From: James Cox
Sent: 02 April 2019 08:51
To: Rob Smith
Subject: RE: Woodsmith Mine - NYM/2019/0129/NM [NLP-DMS.FID262297]

Further to your email below, please find attached final revised drawings to reflect a RAL 7016 finish on the roof.

Project: **653 York Potash**
 Drawing Title: Mining Buildings Elevation Study - Colour
 Scale: 1 : 50 @ A1
 Drwg. Created: June 2014

Drwg. No: **653-AP-0058**
 Status: **Issue**
 (Not for Construction)
 Revision: **10**

DRAWING TITLE: Service Shaft Setting Out Elevations

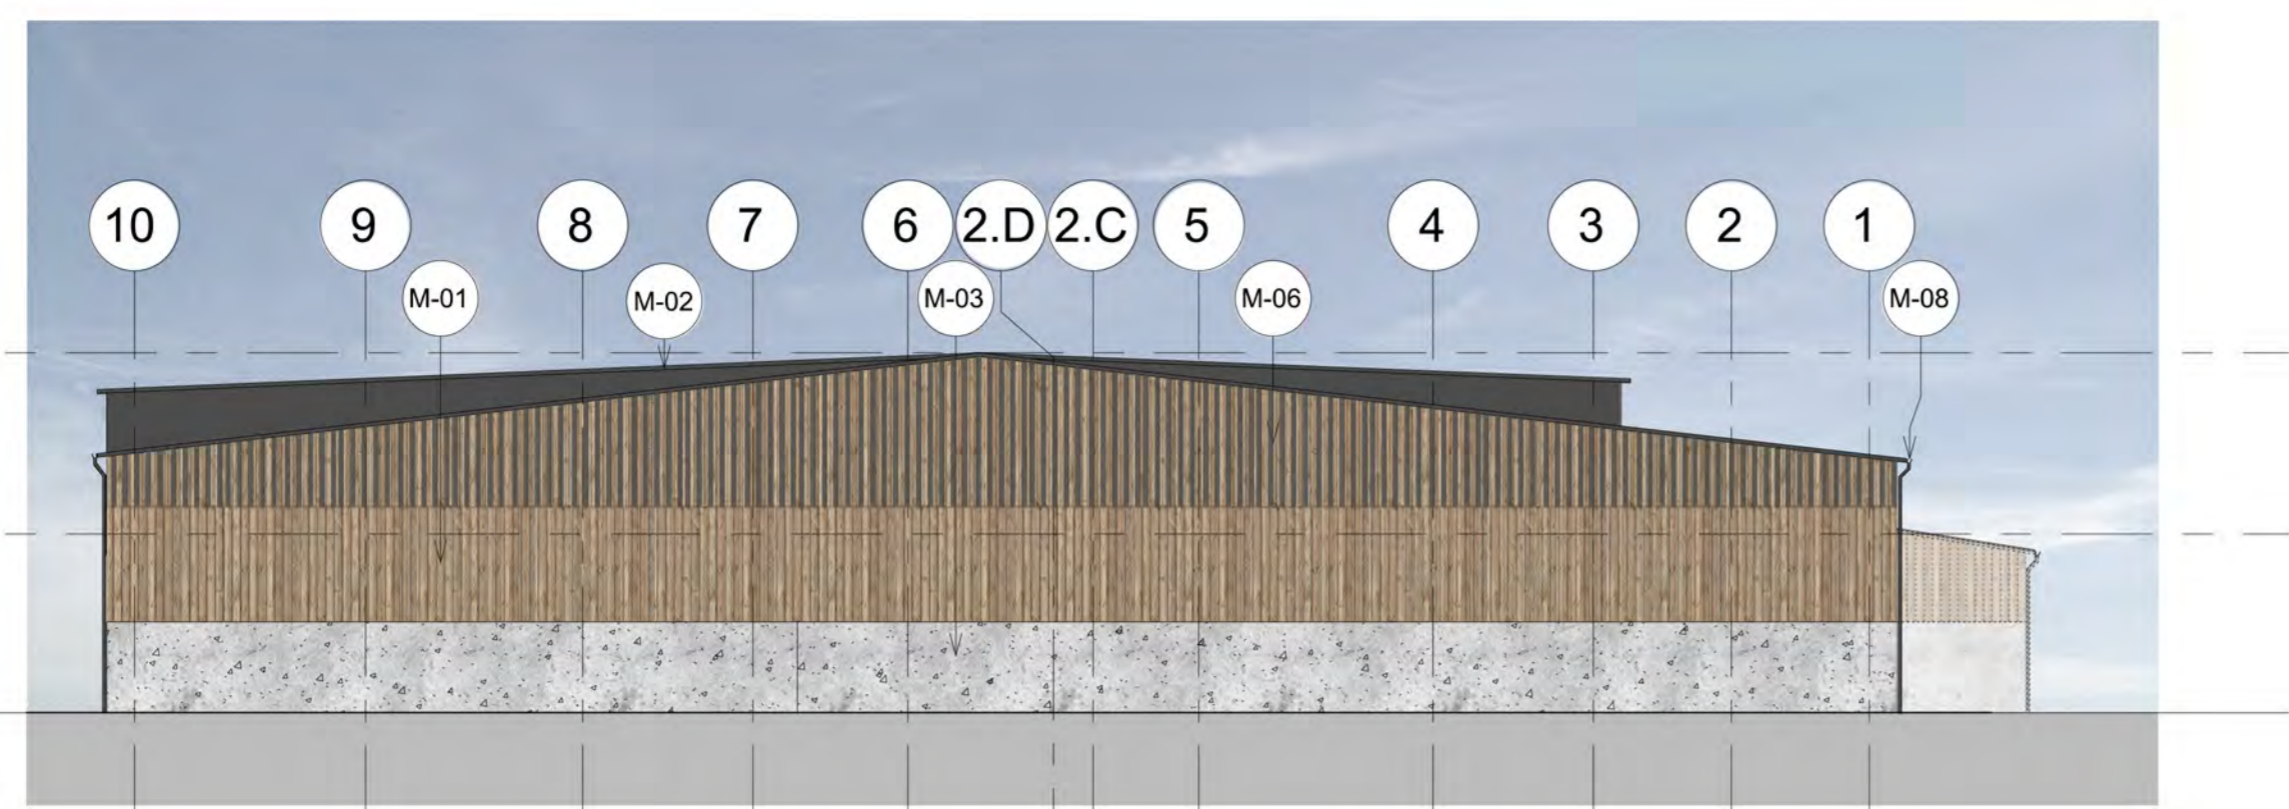
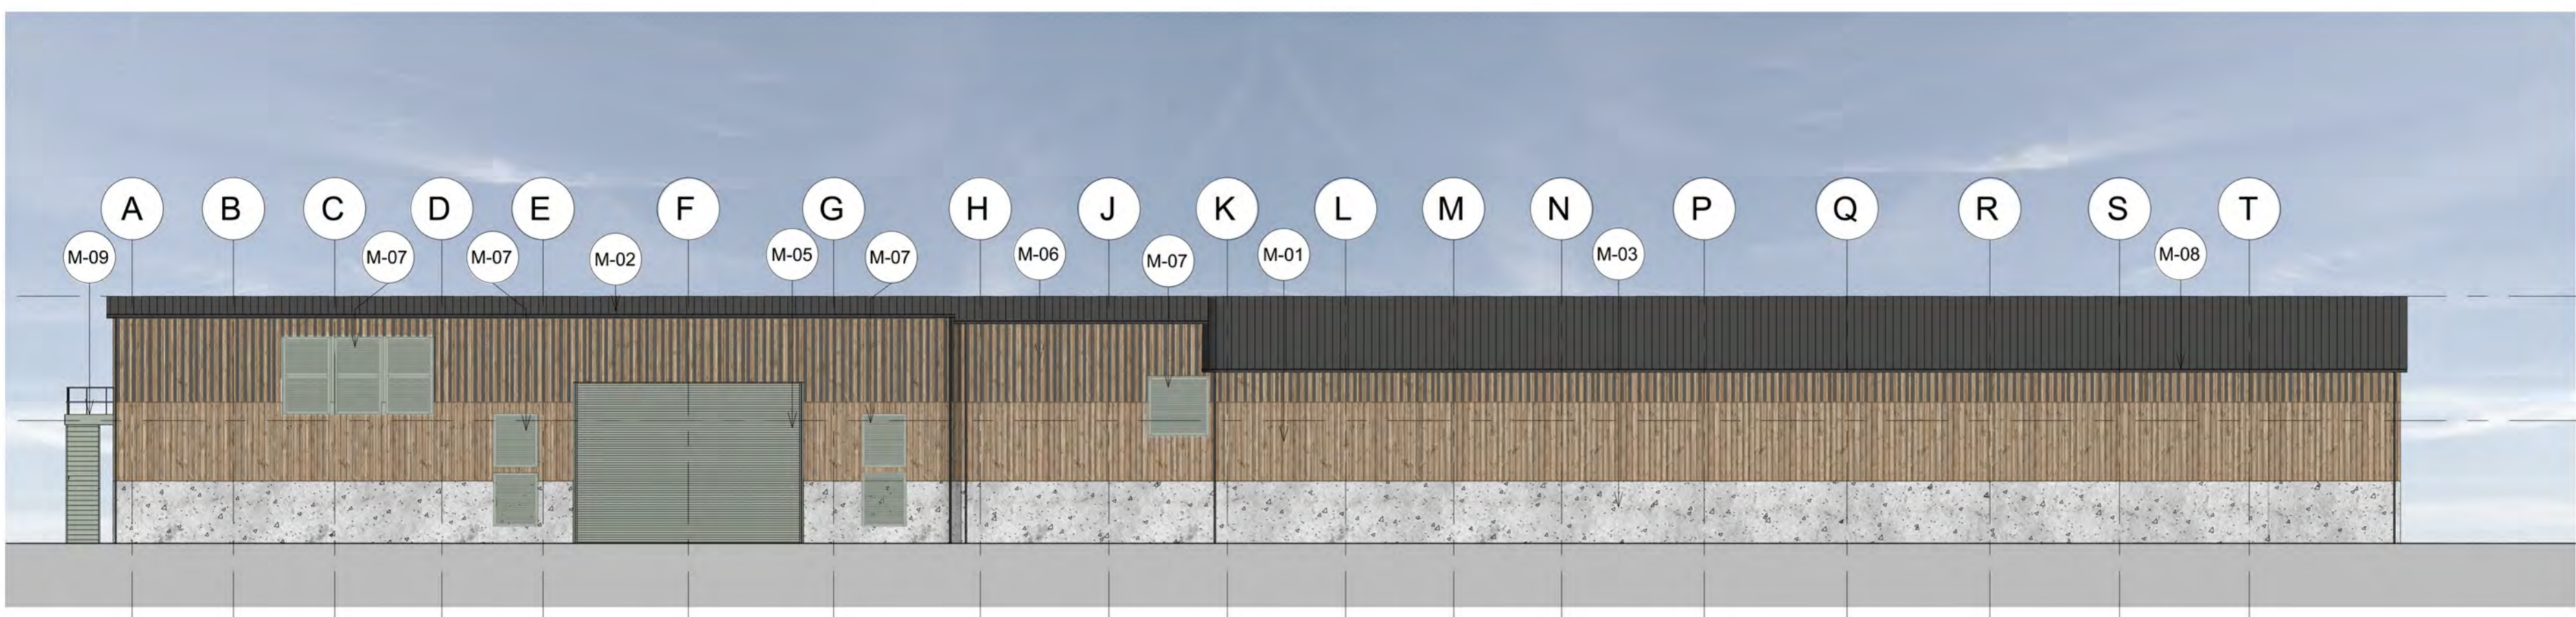
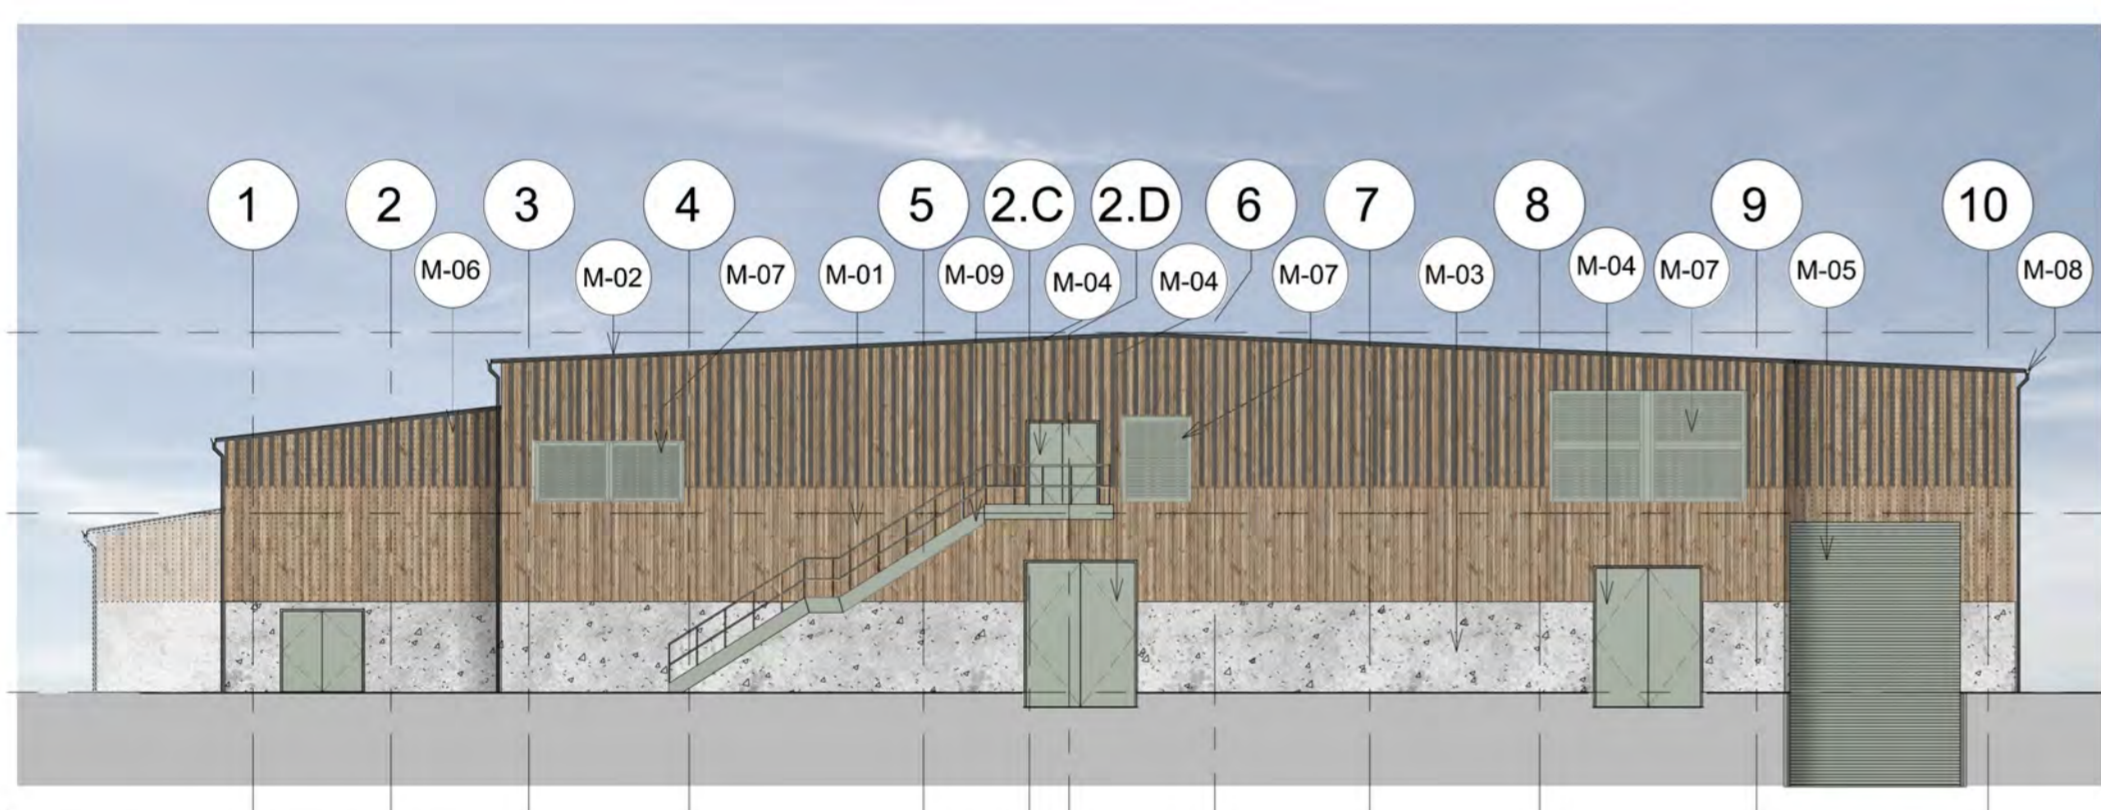
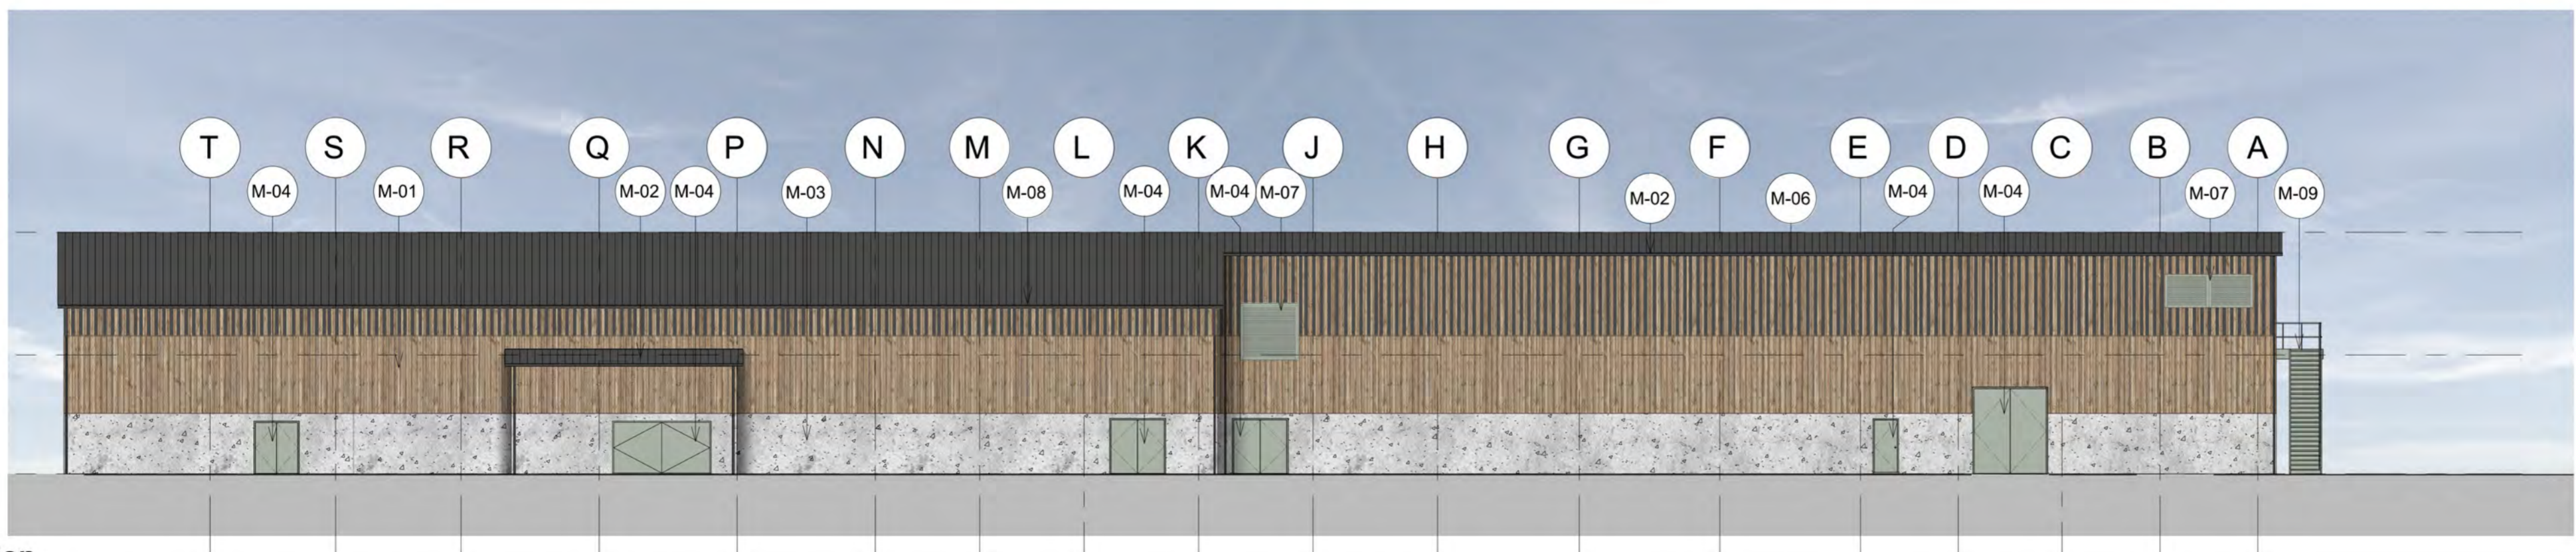
REVISION	DESCRIPTION	DATE	BY	CHKD	APPD
P	ROOF RAL COLOUR UPDATED	04/01/19	AK	JS	IW
N	RAL COLOUR UPDATED	25/03/19	AK	JS	IW
M	CLADDING INTERSECTION LOCATION UPDATED	15/03/19	AK	JS	IW
L	RAL COLOURS UPDATED	11/03/19	AK	JS	IW
K	RAL COLOUR AMENDED	05/03/19	AK	JS	IW
J	UPDATED FURTHER TO COMMENTS	20/02/19	AK	JS	IW
H	UPDATED FURTHER TO COMMENTS	20/02/19	AK	JS	IW
G	UPDATED FURTHER TO COMMENTS	19/02/19	AK	JS	IW
F	UPDATED FURTHER TO COMMENTS	18/02/19	AK	JS	IW

- MATERIAL KEY**
- M-01 Timber wall cladding (wide timber board & narrow gap)
 - M-02 PPC 'Anthracite Grey' non-reflective coated profiled sheet metal roof cladding (RAL 7016)
 - M-03 Concrete panel cladding
 - M-04 PPC 'Agate Grey' non-reflective coated metal industrial access door (RAL 7038)
 - M-05 PPC 'Agate Grey' non-reflective coated metal industrial roller shutter (RAL 7038)
 - M-06 Timber wall cladding (narrow timber board & wide gap)
 - M-07 PPC 'Agate Grey' galvanised metal ventilation panel (RAL 7038)
 - M-08 PPC 'Anthracite Grey' non-reflective rainwater goods (RAL 7016)
 - M-09 PPC 'Agate Grey' non-reflective metal staircase (RAL 7038)
